WASHINGTON PUBLIC POWER SUPPLY SYSTEM

Subject: NUCLEAR PROJECT NO. 3  
RESOLUTION OF KEY LICENSING ISSUES  
FINAL SUBMITTAL OF SOIL STRUCTURE  
INTERACTION INFORMATION

WASHINGTON PUBLIC POWER SUPPLY SYSTEM  
WNP-3 SEISMIC DESIGN BASIS MODEL VALIDATION EFFORT  
AUGUST 1988

Figure (AF-2)-2

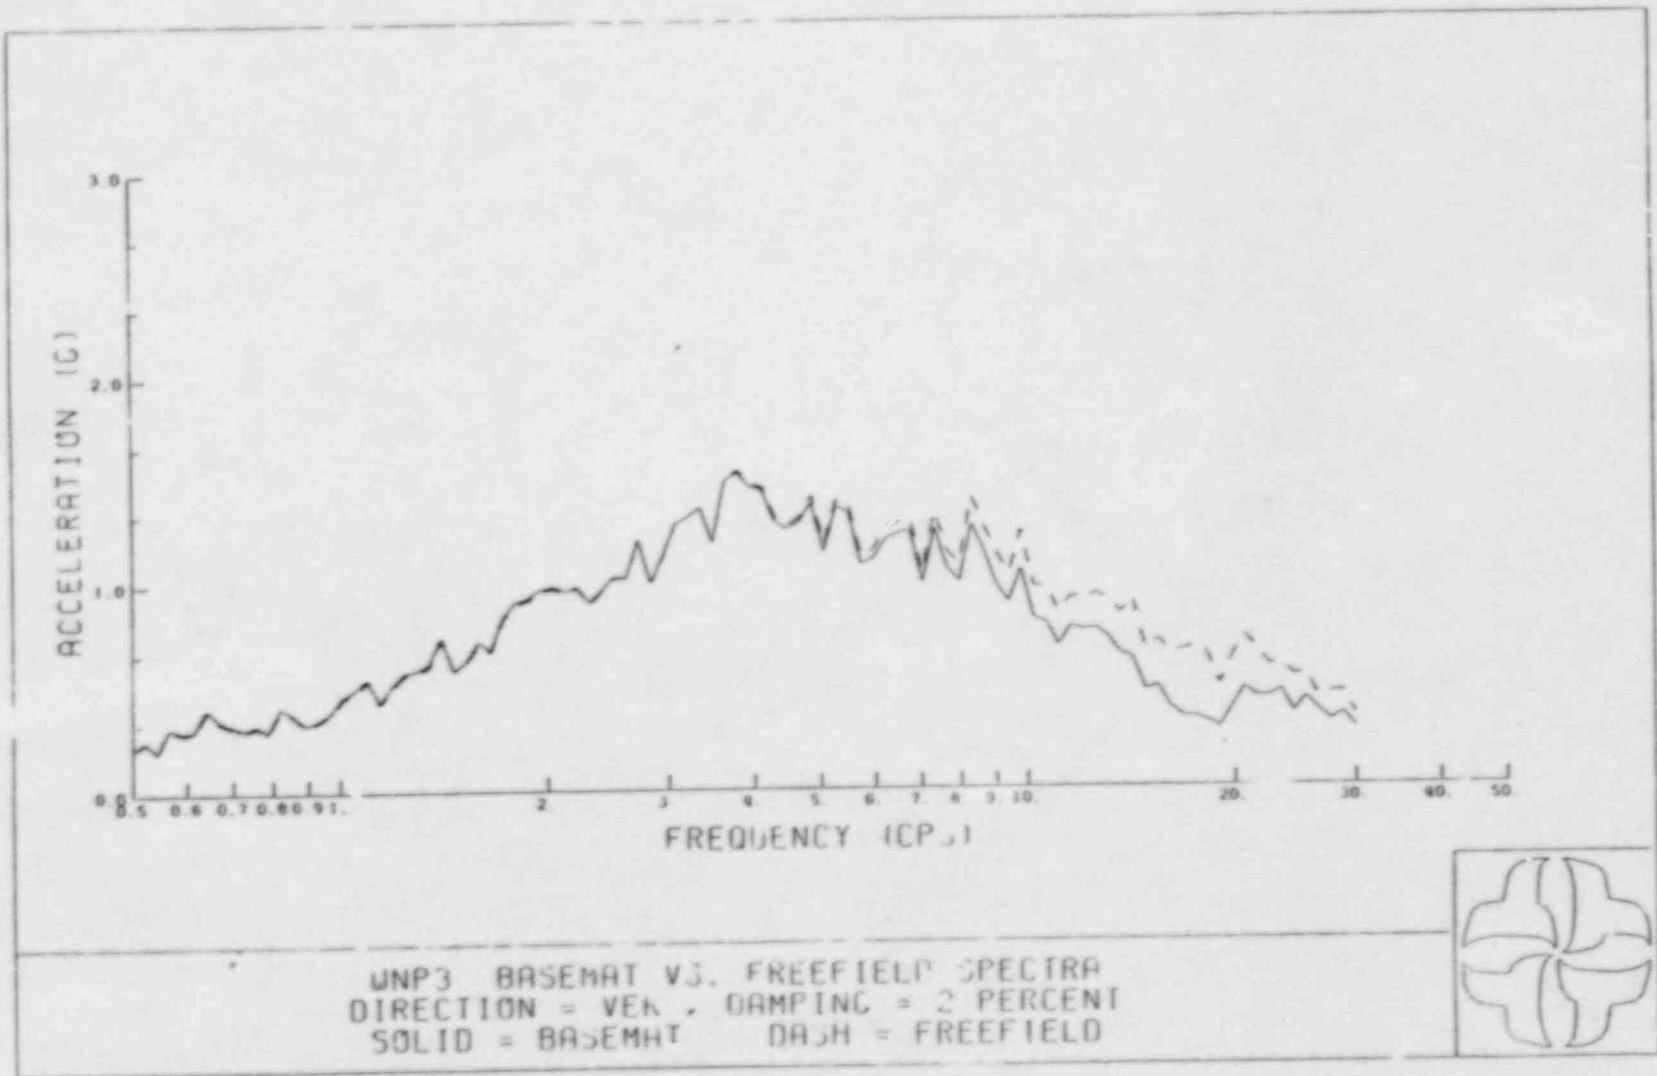
Figures (AF-1)-1 and (AF-1)-2 show a comparison of the SASSI spectral results obtained at the basemat foundation elevation with the free-field or control motion input to the SSI analysis. These figures depict the effects due to SSI. As expected, it is seen that some reduction does occur as compared with the free-field motion. Also as expected, the interaction effects are shown to be more significant in the range of the structural frequencies (e.g., approximately 3 to 20 Hz, depending on motion direction, with reductions as large as 45 percent). At very high frequencies, the free-field motion and the interaction motion are basically identical. This particular effect demonstrates the conservatism of the SASSI calculations. In addition, the SASSI methodology has been shown to conservatively predict reductions of motion over the embedment depth as compared to actual recorded responses. This was demonstrated, for example, by the Lotung experiment where SASSI predicted reductions of a lesser magnitude than those actually recorded.

In conclusion, the Supply System finds that deconvolution in a rock media is substantiated by theory and published seismic data for comparable rock sites. Thus, the Supply System recommends that the NRC's concern as identified in AF-1 be closed.
